Technical Service Bulletin

MODEL(S) AFFECTED: **Following models equipped with Emergency Stop Button**
Manufactured between serial number range 10697300- 10708400 (July 10 - Sept 3, 2014):
SpeedGleam 5, SpeedGleam 7, SpeedGleam Rider, Strive, Strive Rider, Speed Scrub 17/20 (SS3), Speed Scrub 24/32 (SS5) and Speed Scrub Rider

SUBJECT: Functional issue with emergency stop button (Design B). When pressed, the button may not remain engaged in the lock-out position as designed. In this condition, the switch will still disable machine when pressed, but the button must be held for one to two seconds on some models such as the Speed Scrub 24/32 (SS5), Speed Scrub Rider and Strive Rider.

Emergency Stop Button (Design B)

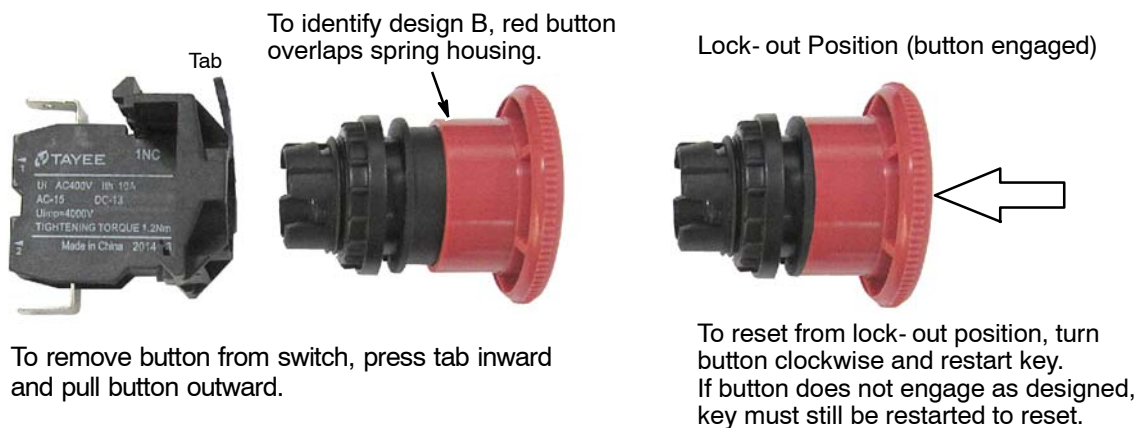
PURPOSE: For machines equipped with emergency stop button (Design B), it's recommended to replace with emergency stop button (Design A) p/n 1011735.

Replace with Emergency Stop Button, p/n 1011735 (Design A)

Note: Both emergency stop button designs share the same part number, confirm correct design before installing. Emergency stop button (Design B) has been removed from inventory.
